*Proceedings of the Madras Government, Public Works Department,  
7th May 1875.*

Notes on Estimates for repairing Arasapathu channel & ca.

Repairing Arasapathu channel

*Cross Section*

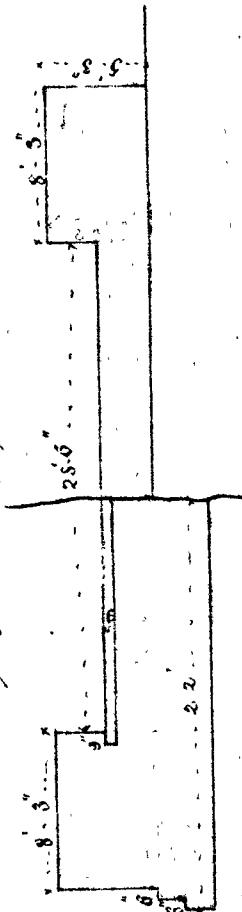
(a) No explanation is given why the masonry wall is required a little above the Calingula at head. There is no information as to the soil on which the wall is to be founded, neither is it explained why a wall 3' in thickness but only 2½' in height is wanted. Mr. Norfor will furnish the requisite information.

(b) Underpinning Calingula wall. The specification prepared by Mr. Norfor seems to show that he does not understand what is wanted. The cracks or holes in the work should be carefully picked out and filled with chips of stone and—

(e) The amount of concrete allowed for underpinning is excessive. It will not of course answer simply to lay the concrete on sand and some foundation is required for it, if the rock can not be reached within a foot or so rubble would probably be best in this case. Holes in the face of the work should be picked out and carefully filled in and

(a) The wall in the Arasa  
pathu channel for which  
3 feet thickness has been  
allowed for a height of  $2\frac{1}{2}$   
feet in superstructure is  
meant to keep the water of  
the channel in its proper  
alignment. This thickness  
was also, I considered, absolutely  
necessary

The average width allowed in the estimate is 2 ft, but it is not necessary that to get this width - the top should be 1 ft and bottom 3 ft, a great portion of this will be utilized to fill up hollows &c in the body wall, the balance only will be used for the construction of this front wall, which in most cases would perhaps have an average width of 1 foot.
